MEMORANDUM

Subject: Addendum to MovingAhead Alternatives Analysis Technical Reports

This document is an addendum to the MovingAhead Project's Alternatives Analysis (AA) Draft Final Technical Reports, dated May 2017. This addendum serves to provide new options for mitigating potential adverse effects as related to the information gathered by the AA Technical Reports.

| MovingAhead Concept Plans | | | COBURG ROAD CORRIDOR ENHANCED CORRIDOR ALTERNATIVE Local Mitigation: Papa's Pizza Parlor |

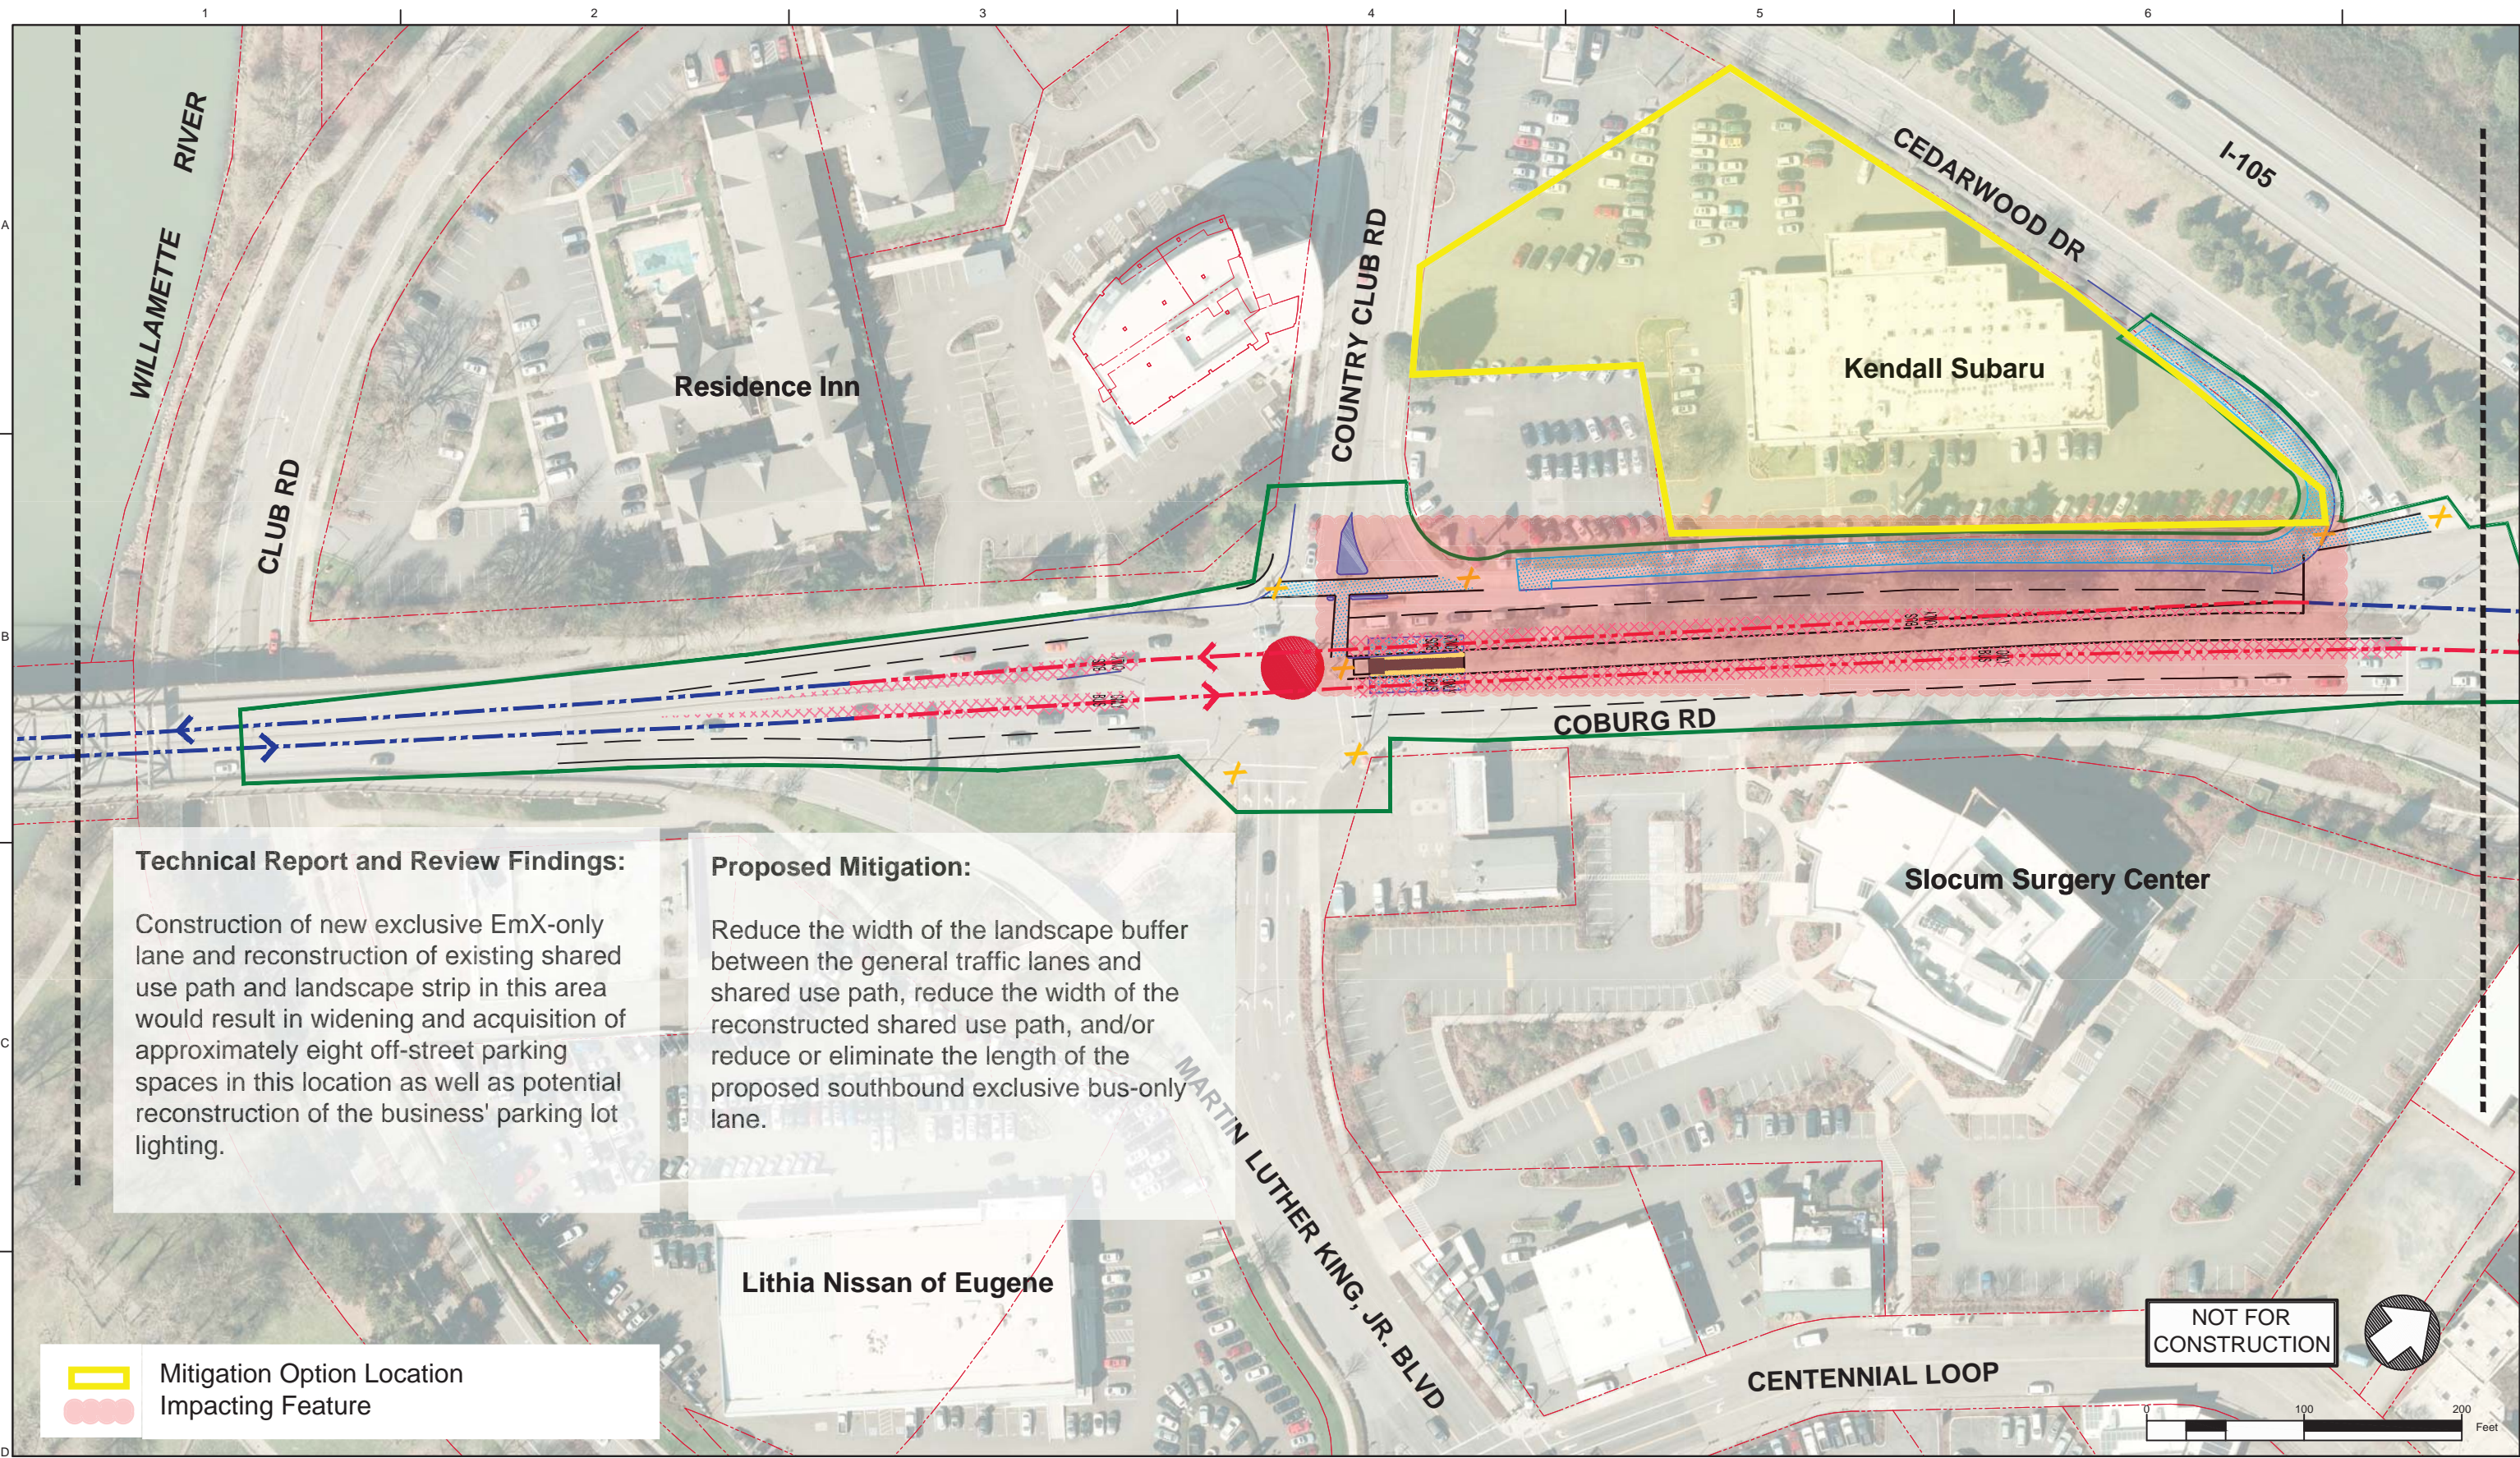
Proposed construction of an extended right-turn lane for the northbound to eastbound turning movement at the intersection of Willakenzie Road and Coburg Road would result in acquisition of approximately 12 off-street parking spaces in this location.

COBURG ROAD CORRIDOR
 EmX ALTERNATIVE
 Local Mitigation: Kendall Subaru

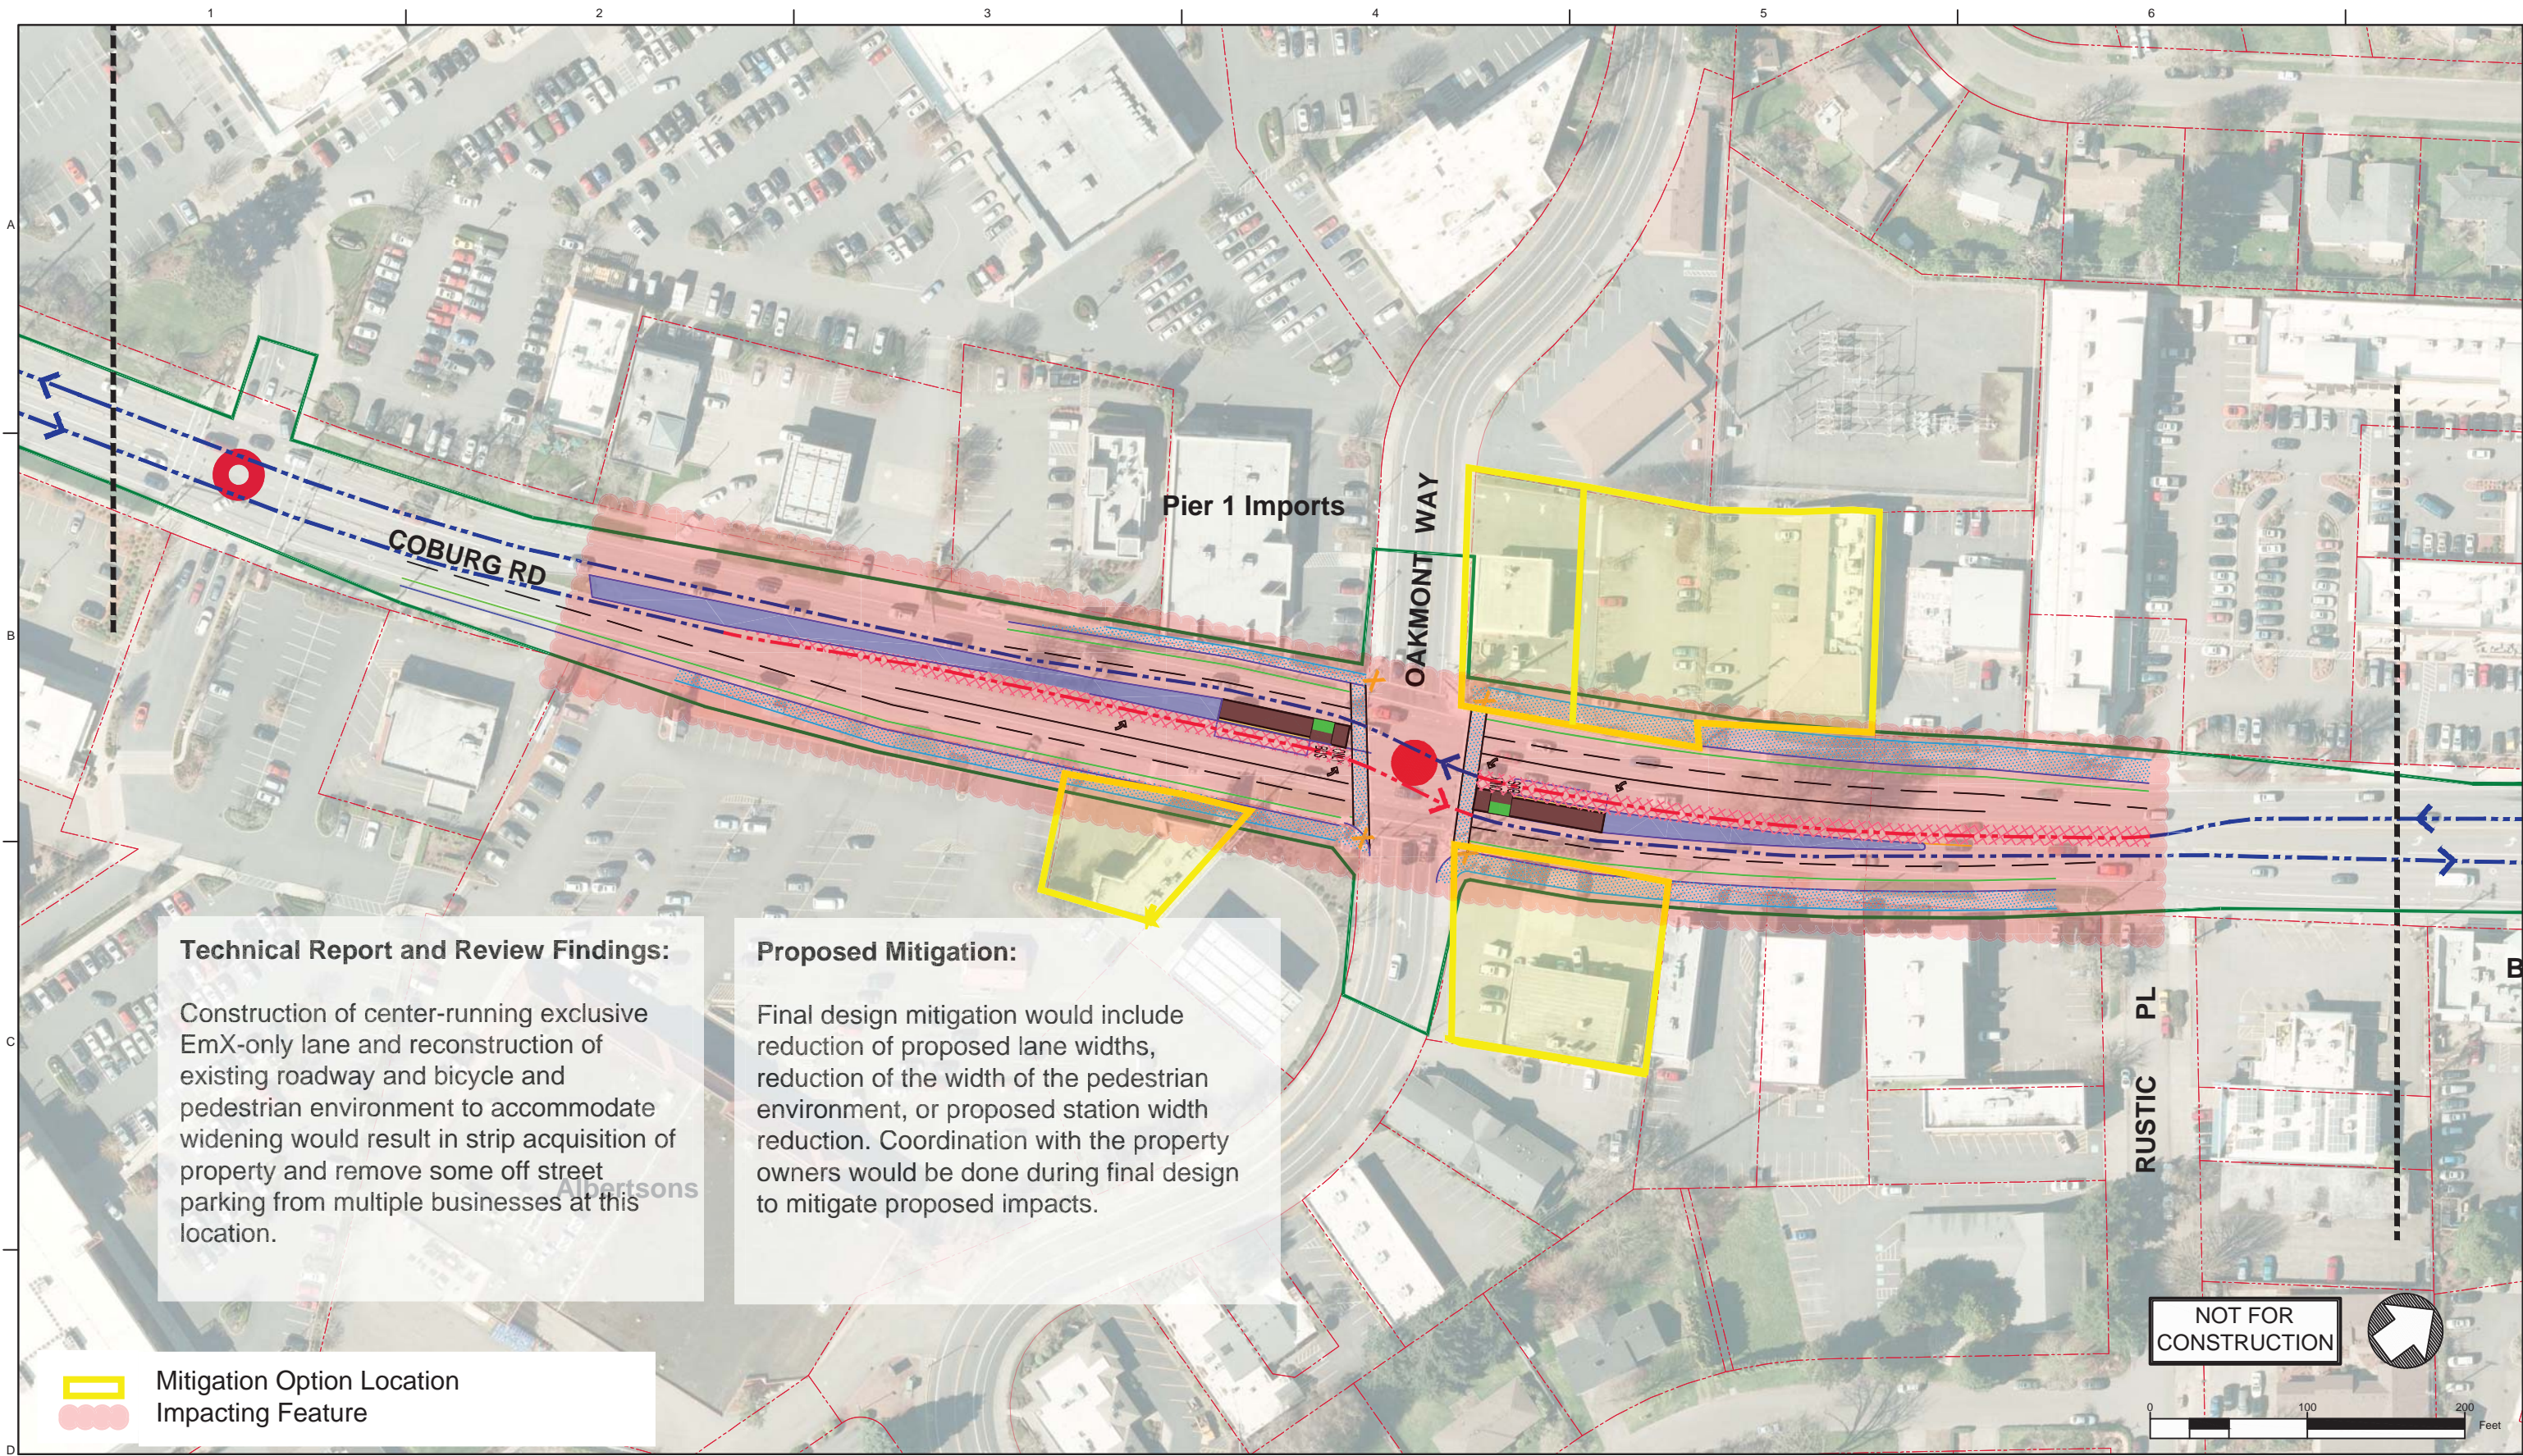
Construction of new exclusive EmX-only lane and reconstruction of existing shared use path and landscape strip in this area would result in widening and acquisition of approximately eight off-street parking spaces in this location as well as potential reconstruction of the business' parking lot lighting.

COBURG ROAD CORRIDOR
 EmX ALTERNATIVE
 Local Mitigation: Oakmont Way Businesses

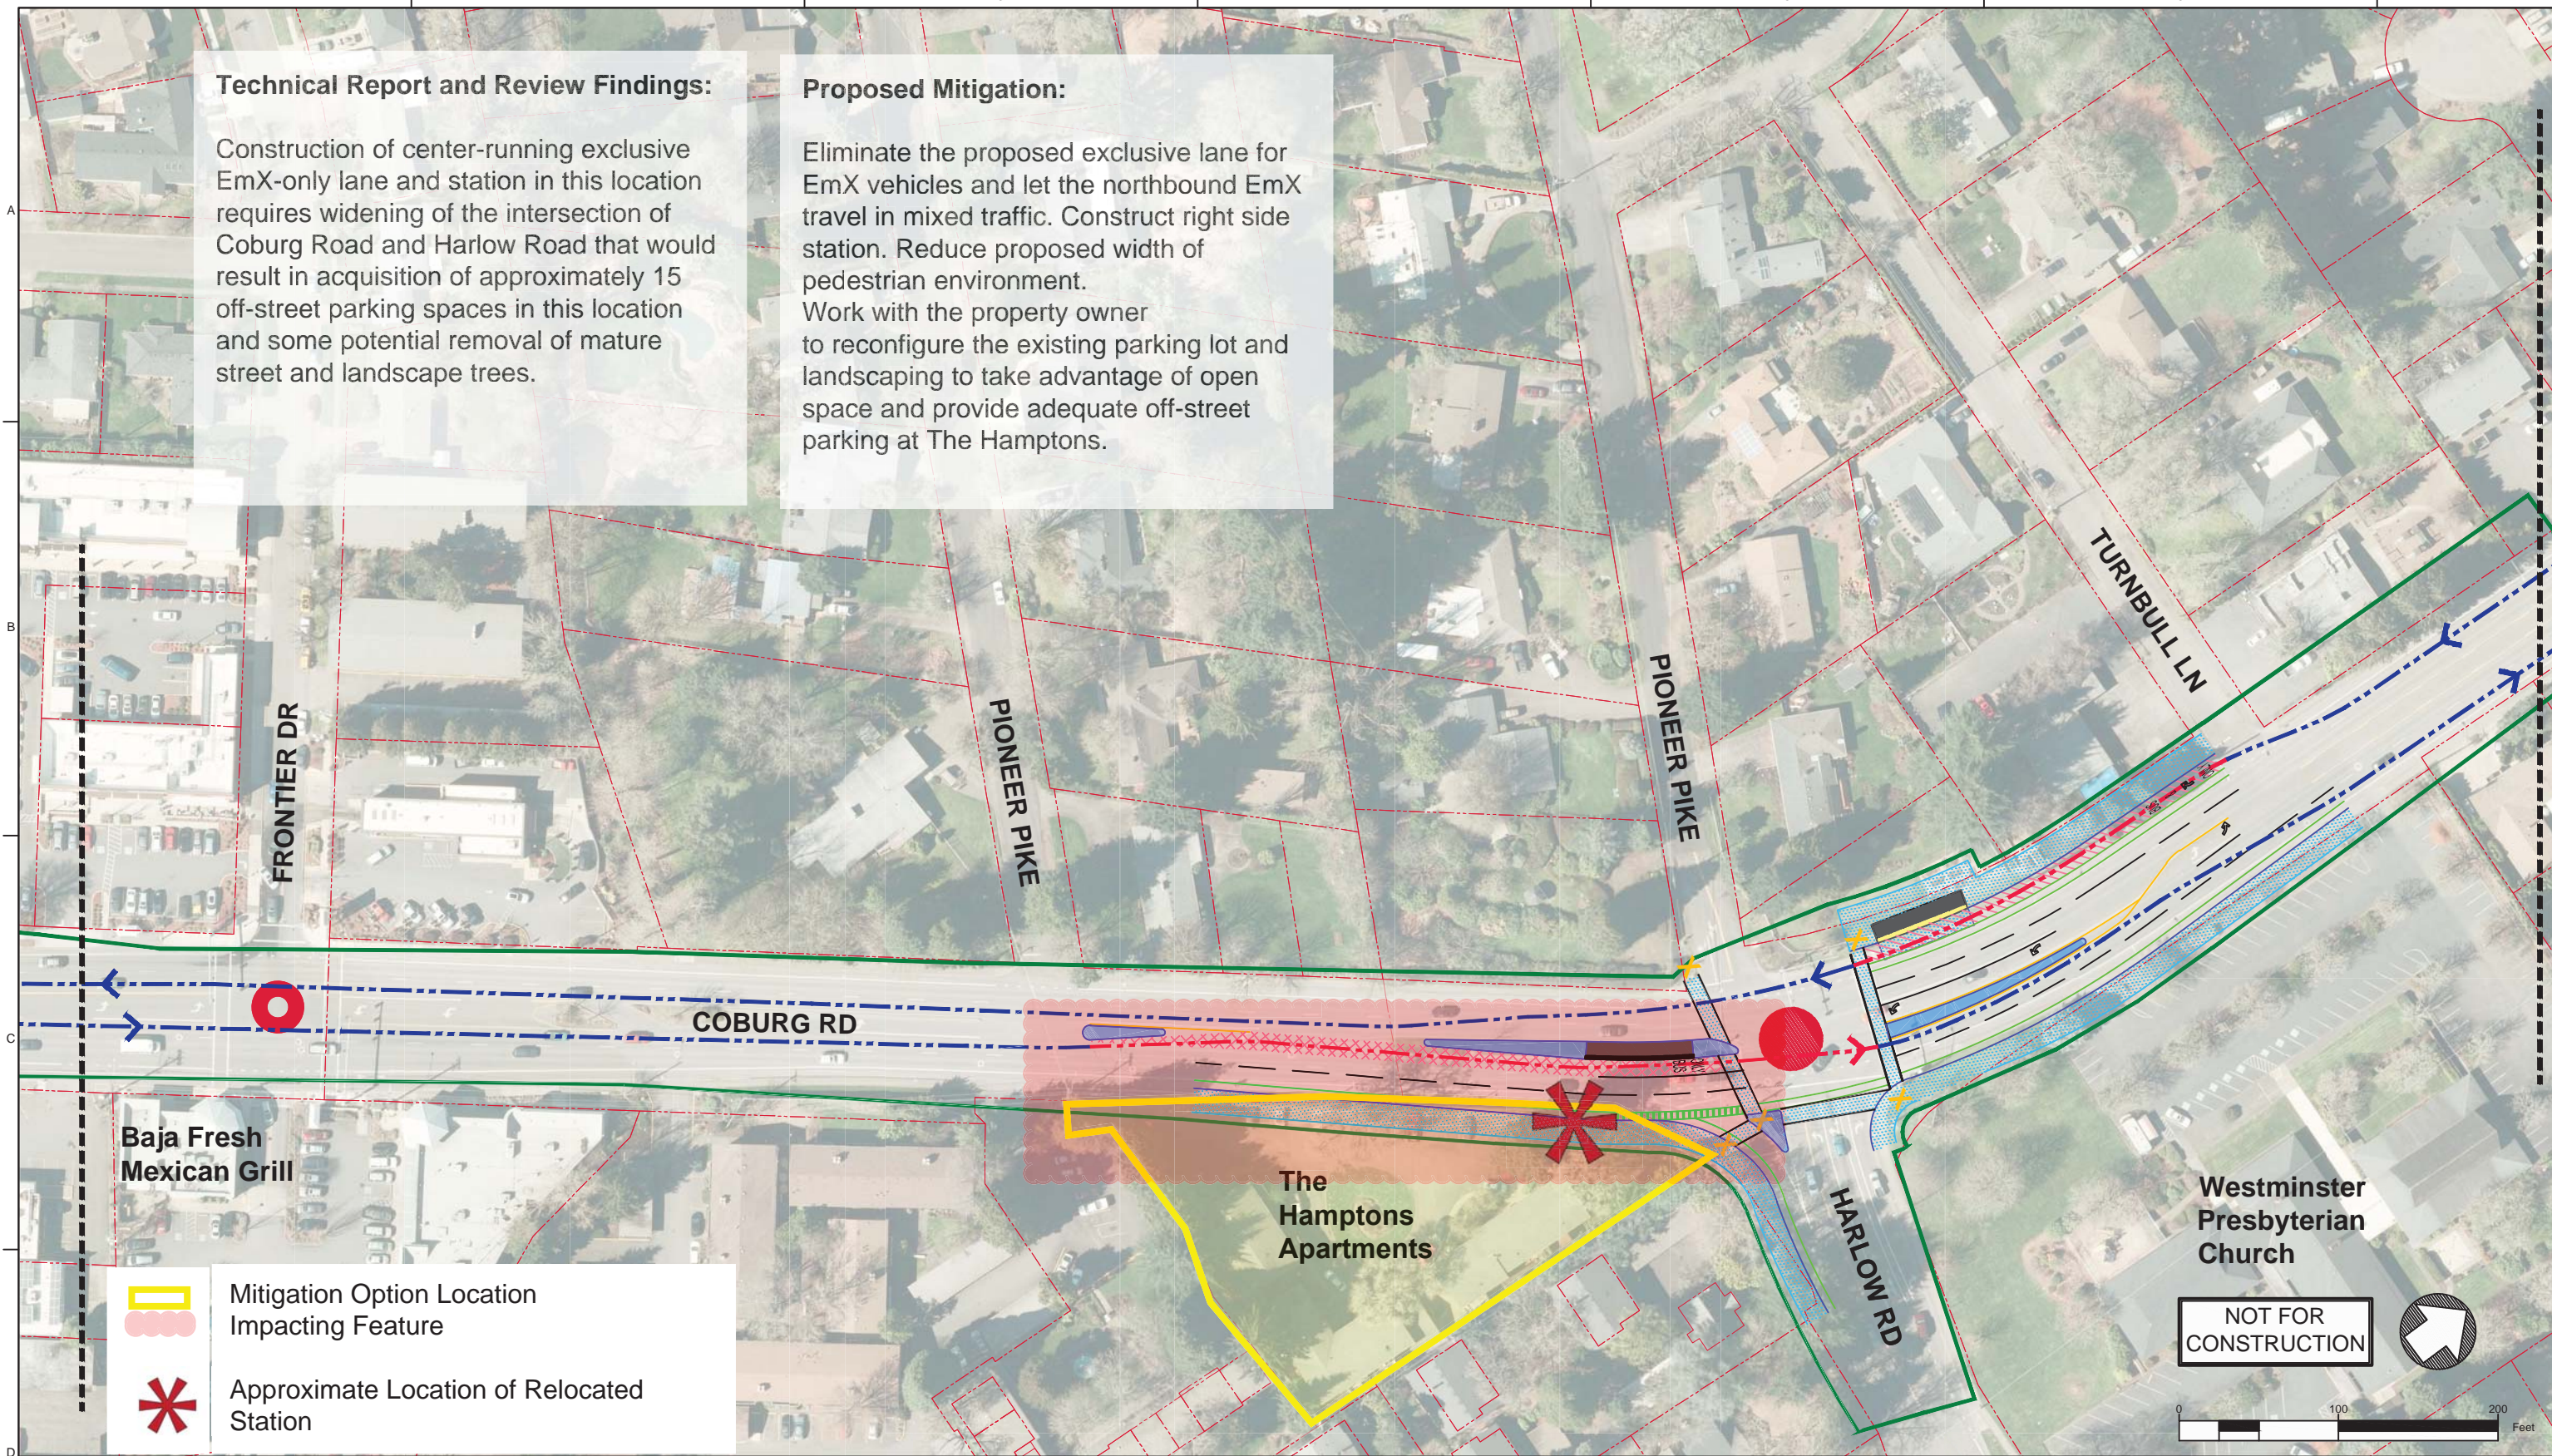
Construction of center-running exclusive EmX-only lane and reconstruction of existing roadway and bicycle and pedestrian environment to accommodate widening would result in strip acquisition of property and remove some off street parking from multiple businesses at this location.
